SOUTHEAST ATLANTA BRANCH LIBRARY

PROJECT: SOUTHEAST ATLANTA BRANCH LIBRARY
LOCATION: 1463 Pryor Road, Atlanta, GA 30315
ARCHITECT: Stanley Love-Stanley.

This Addendum #1 dated September 12, 2014 issued by C D Moody Construction, Co., Inc. is hereby made part of the Southeast Atlanta Library. The changes and/or clarifications included in this Addendum shall be considered as part of the Bidding Documents and shall supersede, amend, add to, or subtract from those conditions included in the original Bid Documents, including the Project Bid Package, Drawings, Specifications, previous Addenda, etc.

This Addendum #2 dated September 25, 2014 issued by C D Moody Construction, Co., Inc. is hereby made part of the Southeast Atlanta Library. The changes and/or clarifications included in this Addendum shall be considered as part of the Bidding Documents and shall supersede, amend, add to, or subtract from those conditions included in the original Bid Documents, including the Project Bid Package, Drawings, Specifications, previous Addenda, etc.

SITE DRAINAGE PLAN

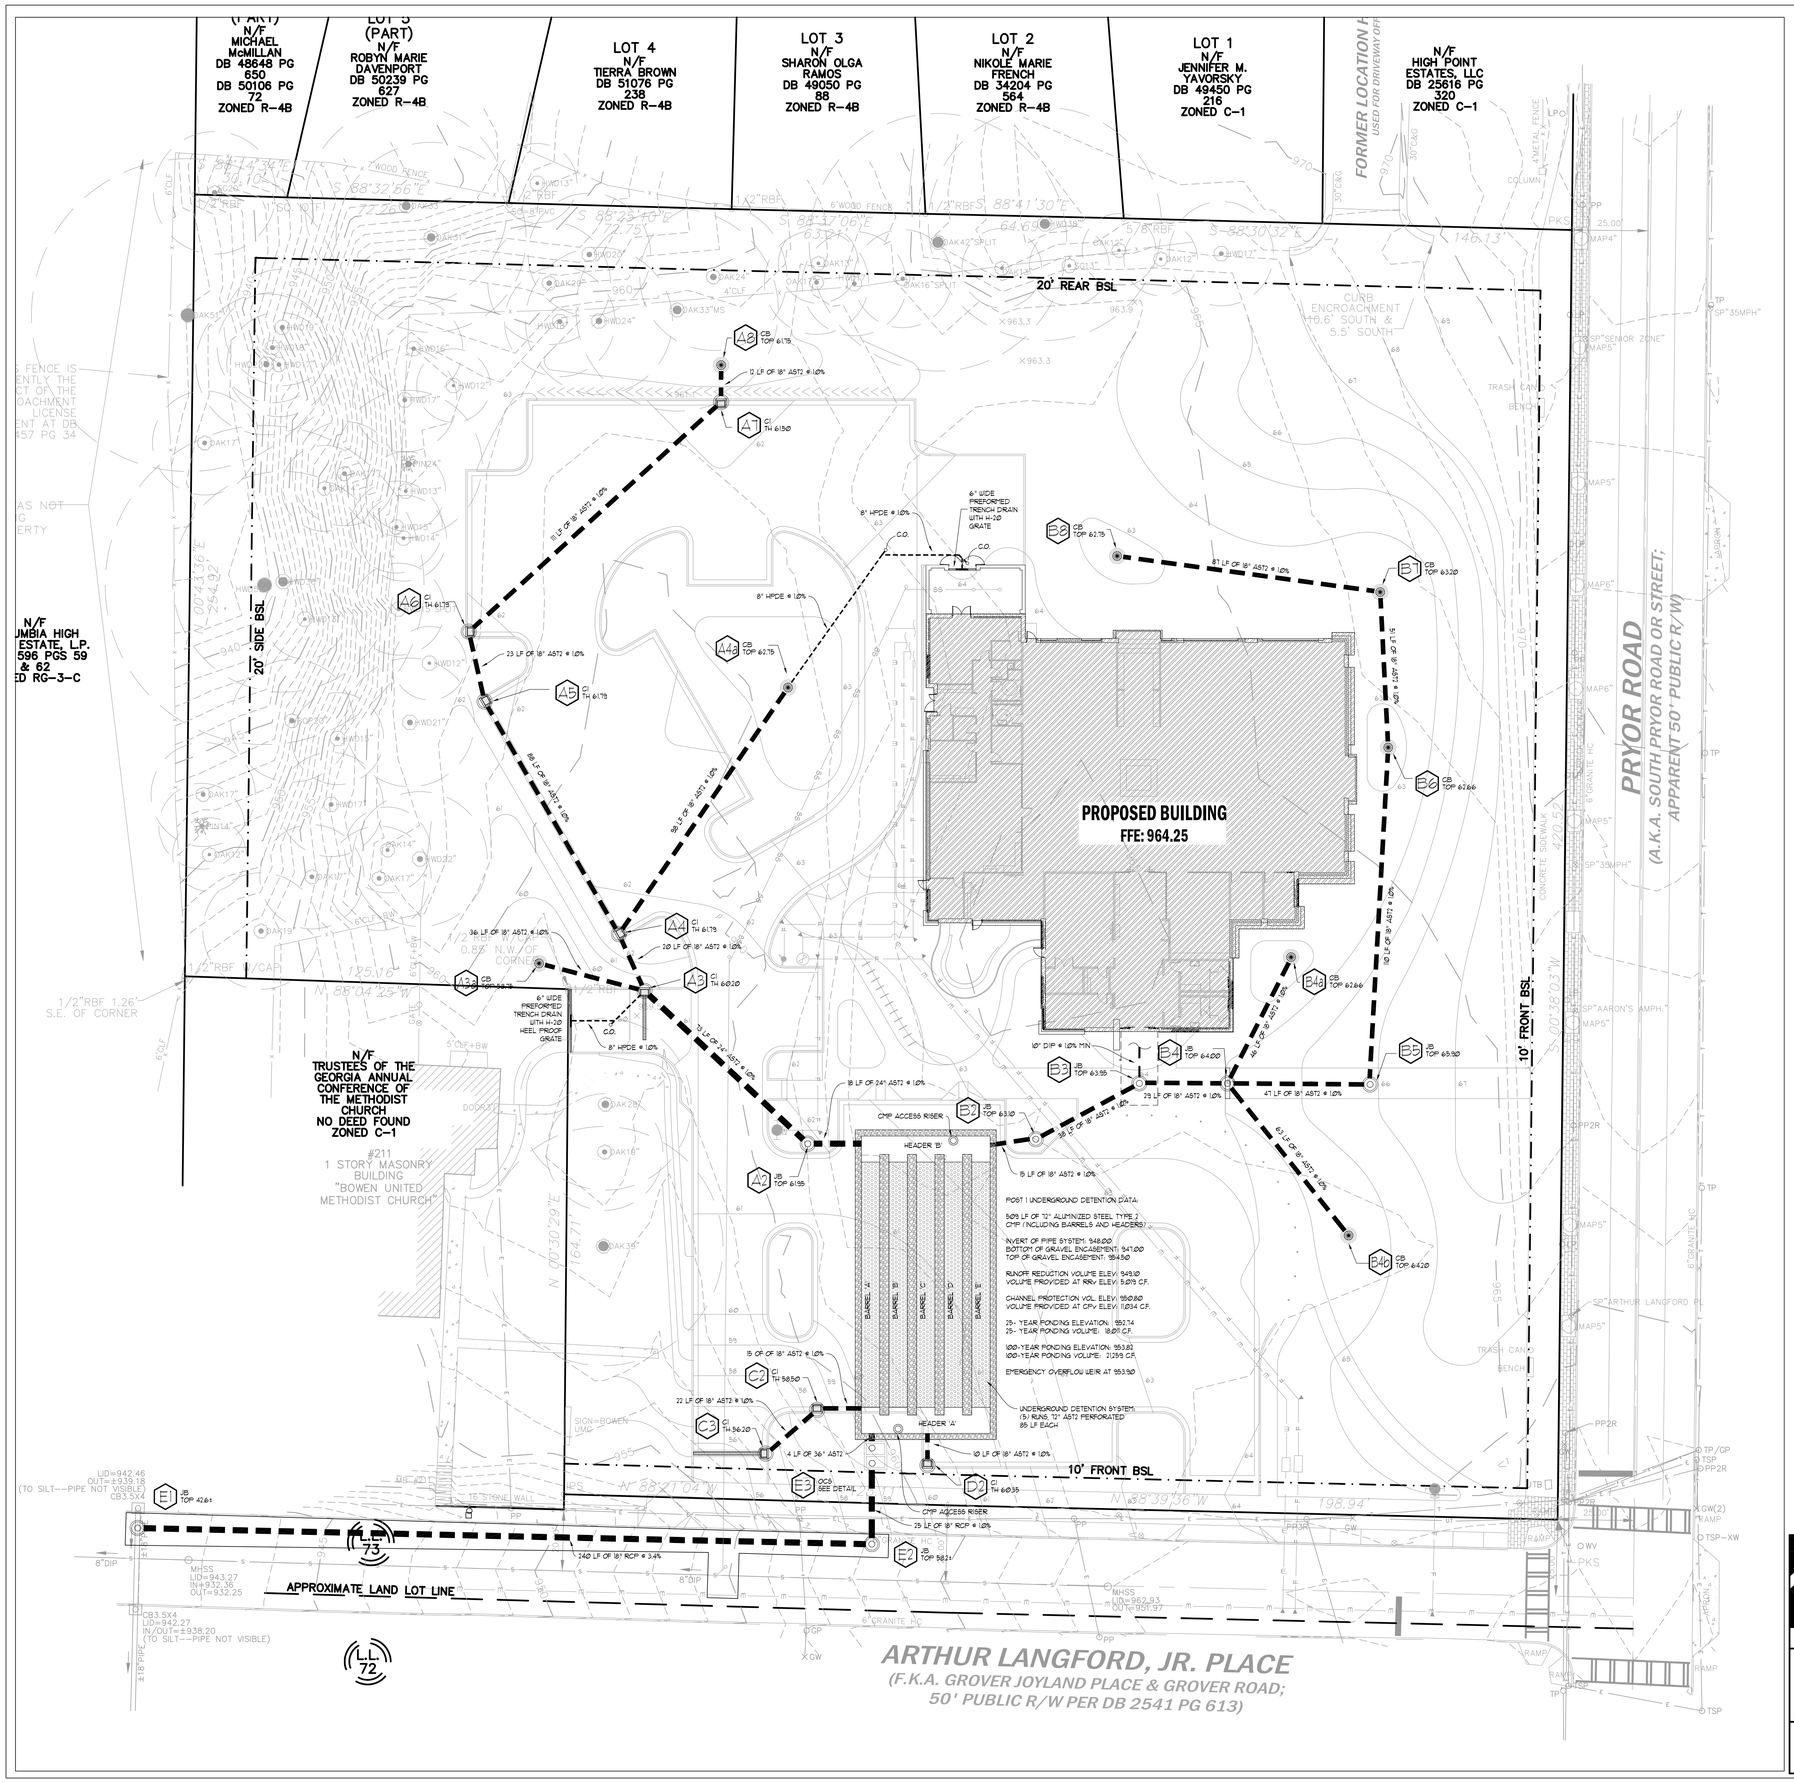
Plumbing Drainage Floor Plan shows locations for downspouts leading from roof drains on the sides of the buildings. Detail 1/C6.10 shows downspout/rainleader cleanout detail but Site Drainage Plan C3.10 does not show locations for piping tie-in to underground storm. Please provide tie-in locations and piping plan.

Response Only one internal drain exits the building, the 10" line to the south. Other roof drains shown on plumbing drawings are overflow from roof that exit via lamb's tongue above grade. Refer to plumbing and architectural drawings for details.

FIRST FLOOR AND FOUNDATION PLAN

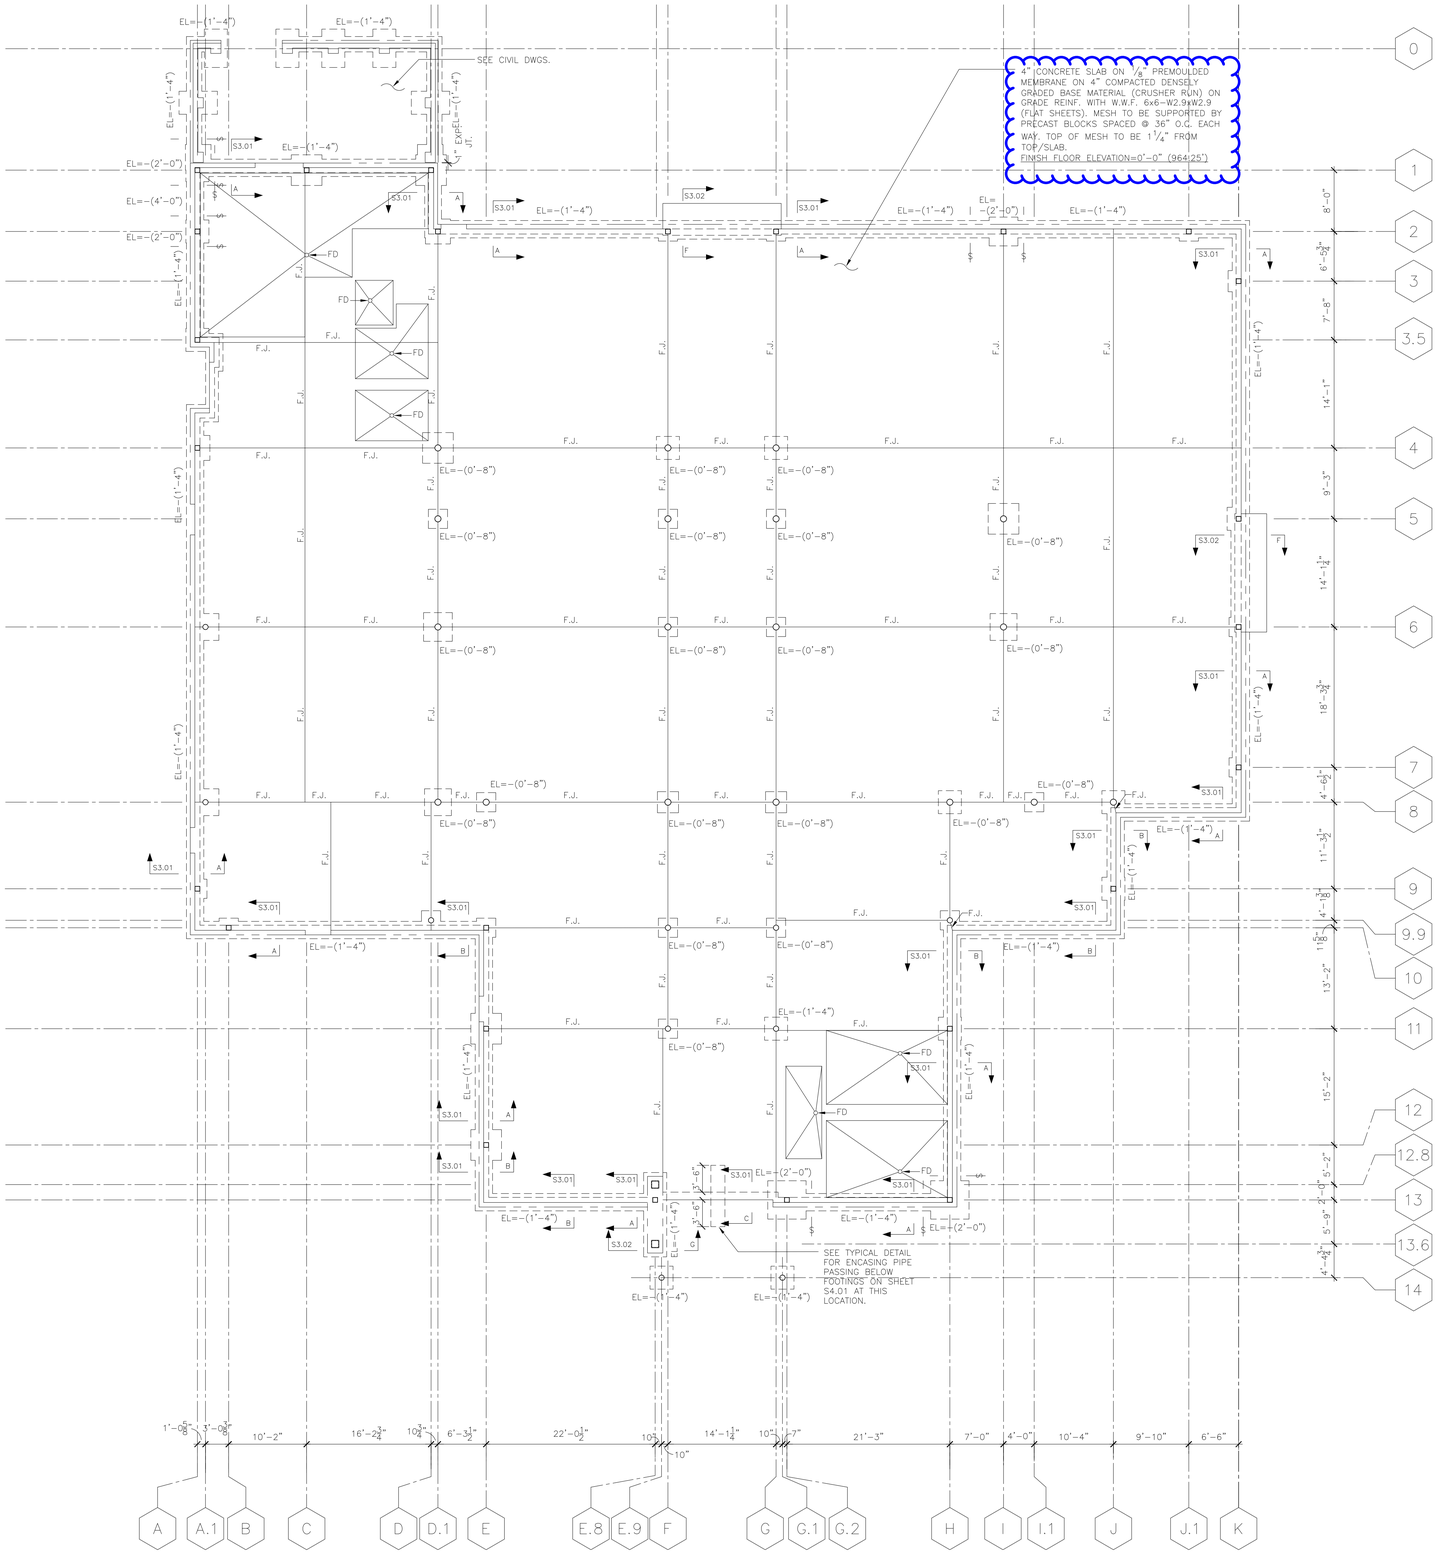
Structural sheet S1.01 notes that base material for slab should be a 4" layer of densely compacted base material (crusher run). The Passive Radon System Detail on M5.01 notes that the base layer directly beneath the slab should be a 4" layer of gas permeable material (clean aggregate or sand). This insinuates that the materials should not be fully compacted to allow for permeability. CDM has a concern that if base layer of material directly beneath the slab is not densely compacted as the Structural Drawings require, there will be Structural issues with the support of the concrete slab above resulting in cracking and possible structural failure of the slab. Please advise. See attached referenced documents.

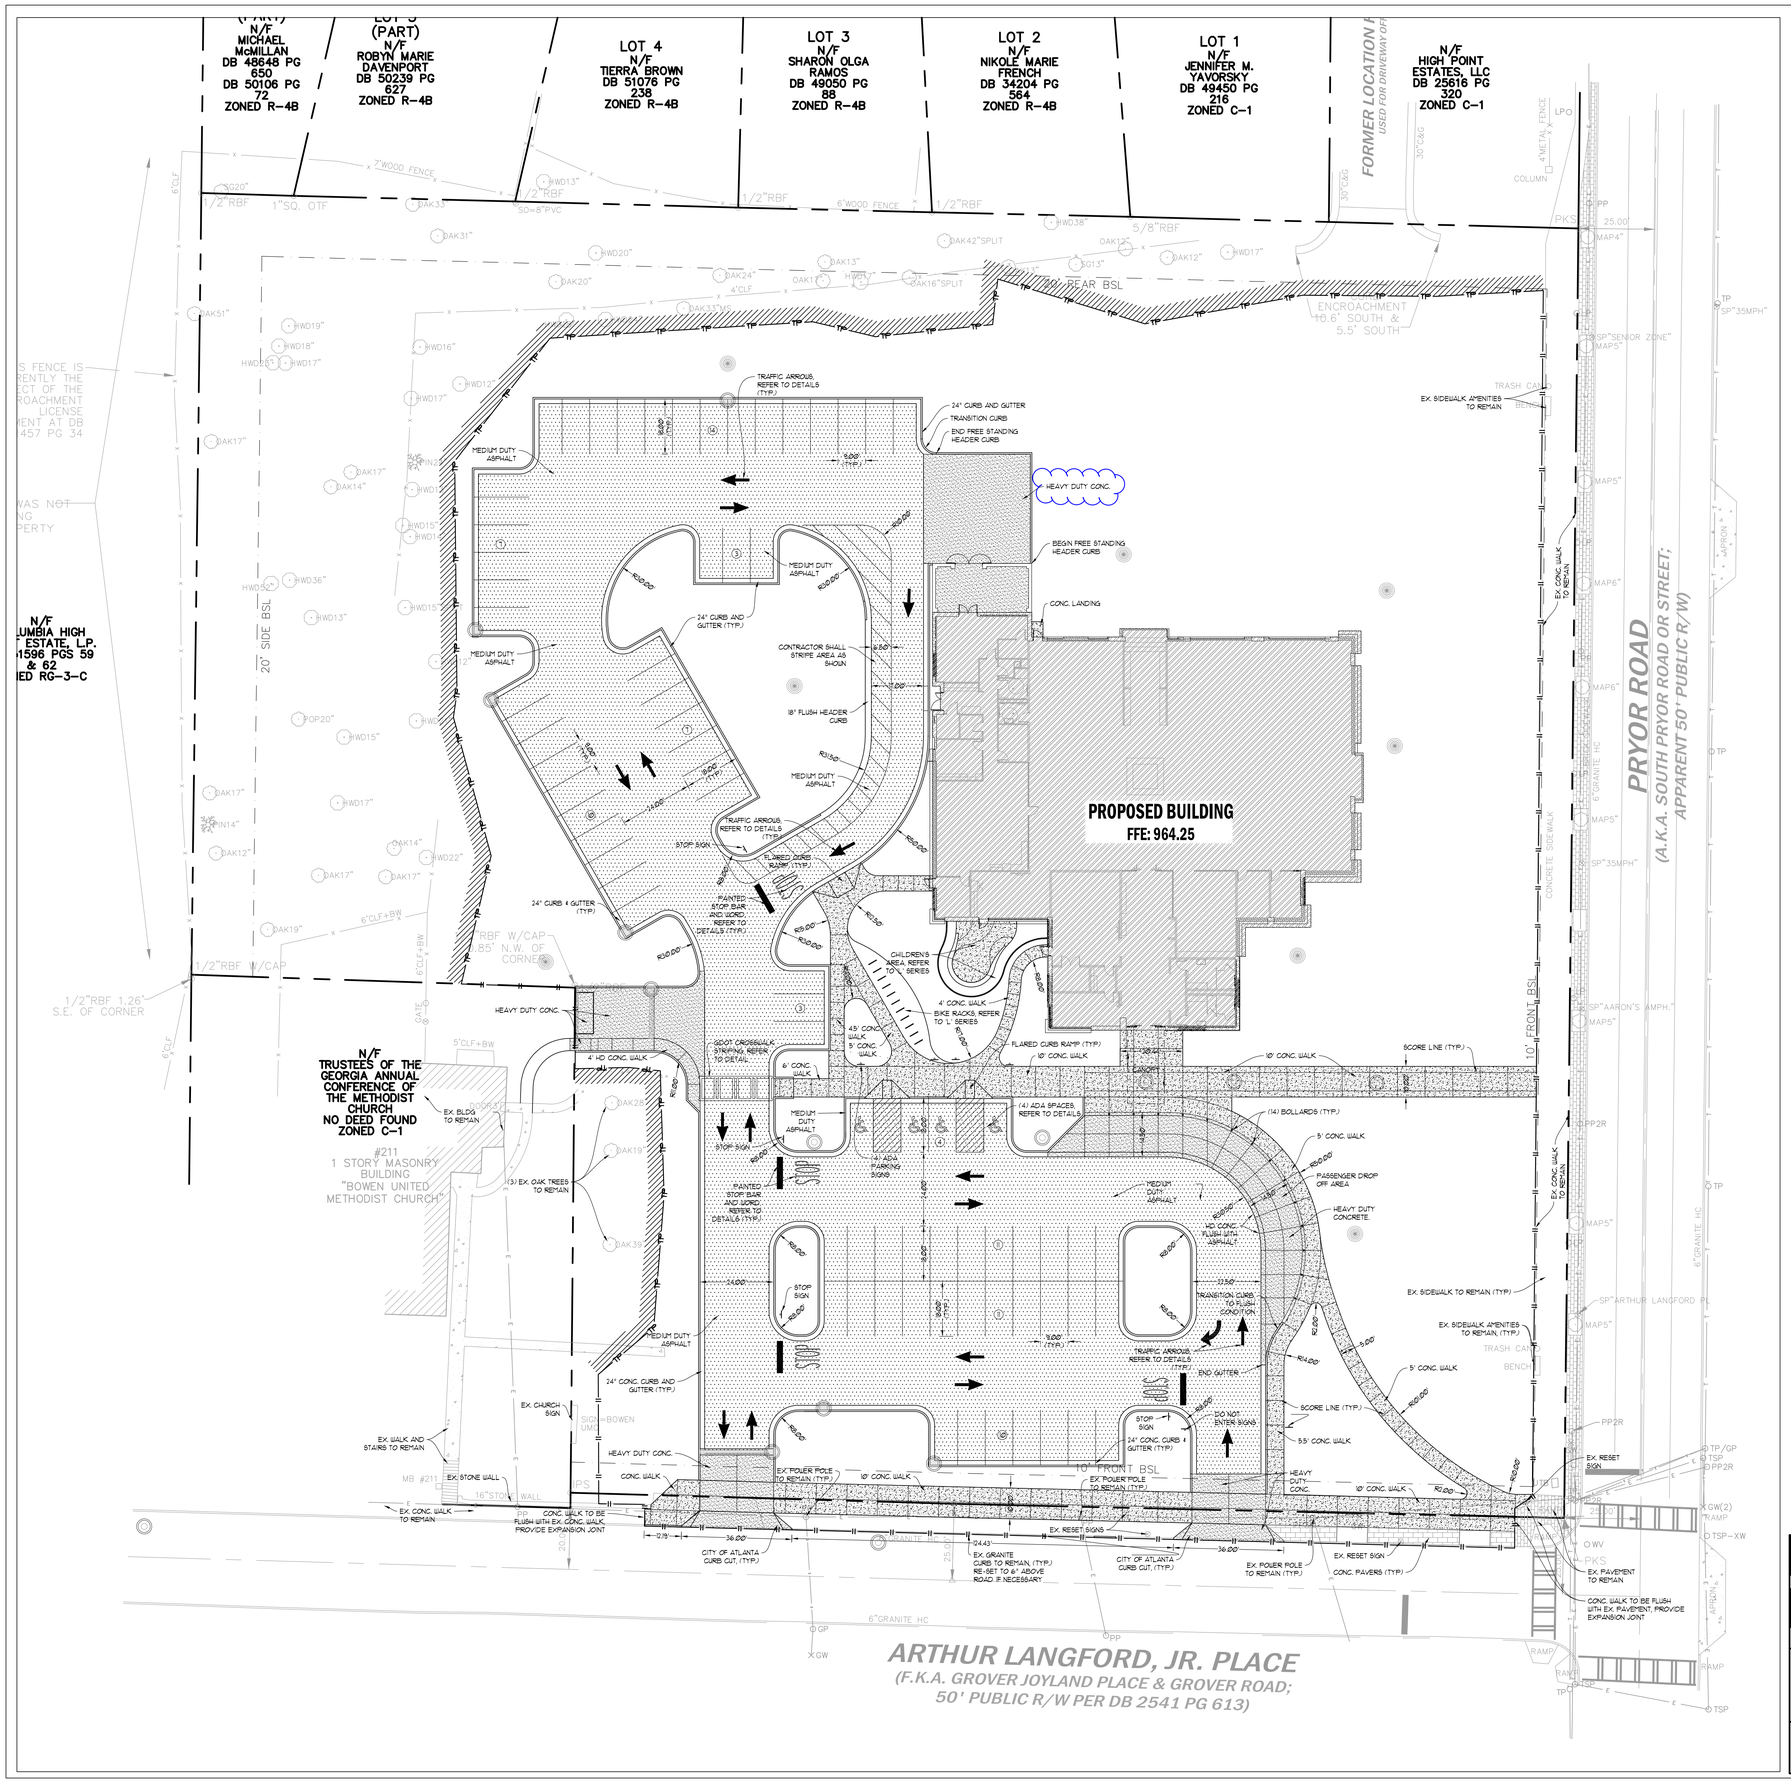
Sheet C2.00 notes that slab for mechnacal yard should be heavy duty pavement (Ref. Detail 3/C6.00). Finish schedule on A1.22 states that the mechanical yard should be gravel. Please confirm mechanical yard will recieve heavy duty pavement.

1 A1.30 FURNITURE PLAN

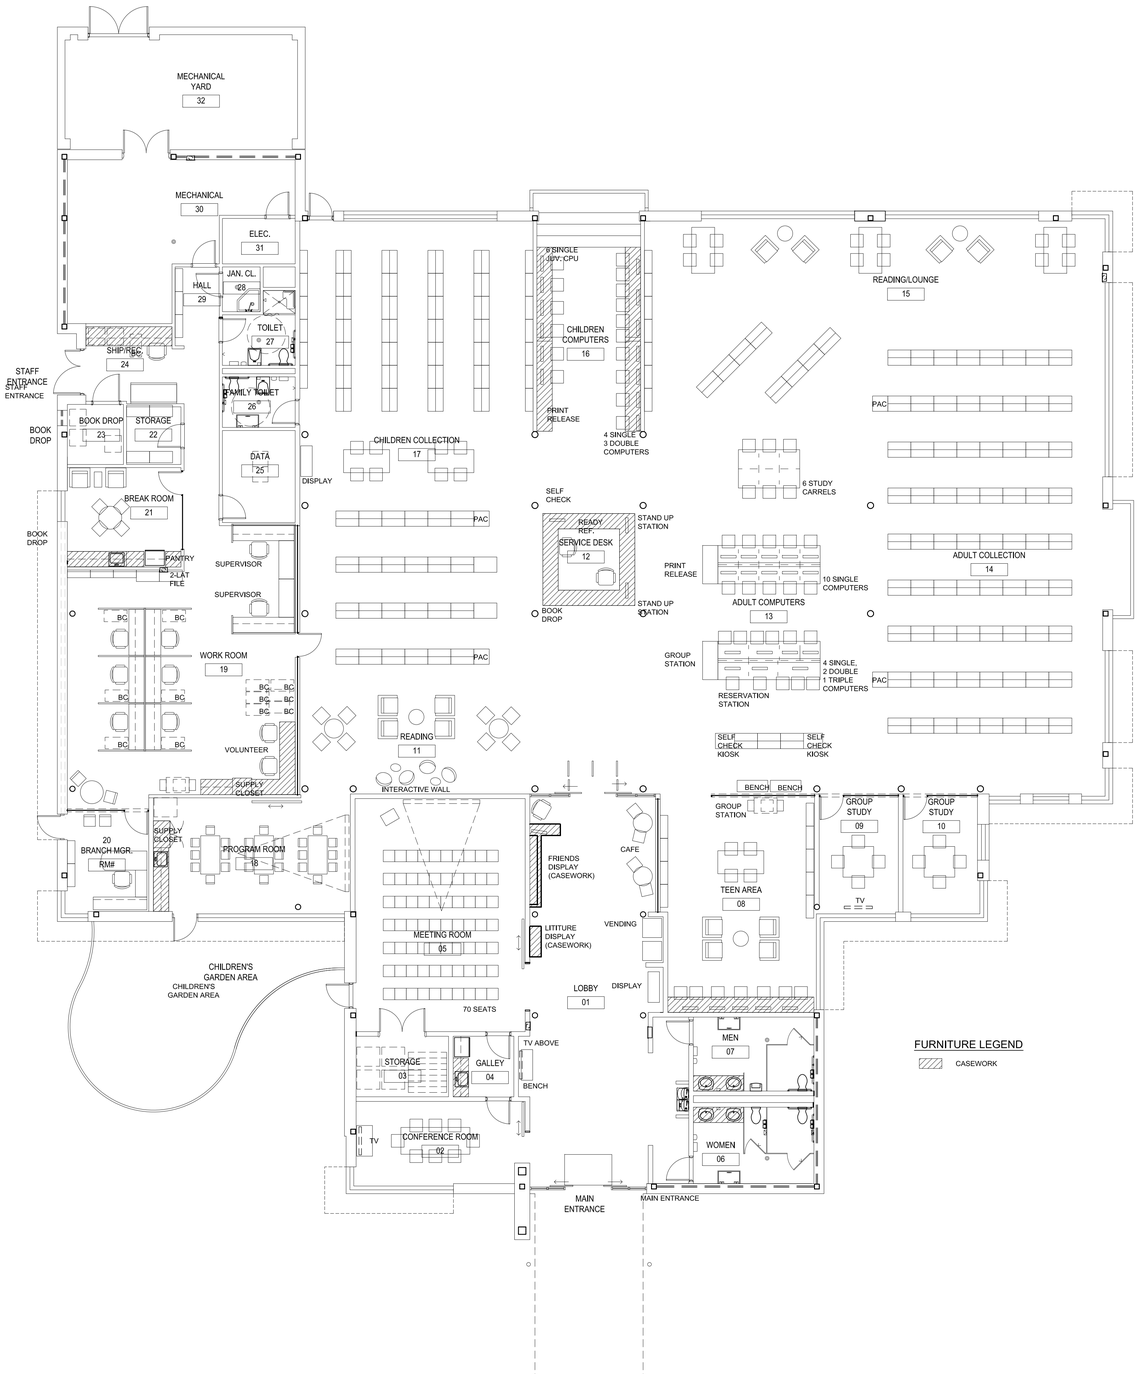
Please revise Furnature Plan A1.31 to show what assembies are included in the Architectural Woodwork and Solid Surface Countertop specifications.

See attachment with A1.31 revised
September 26, 2014
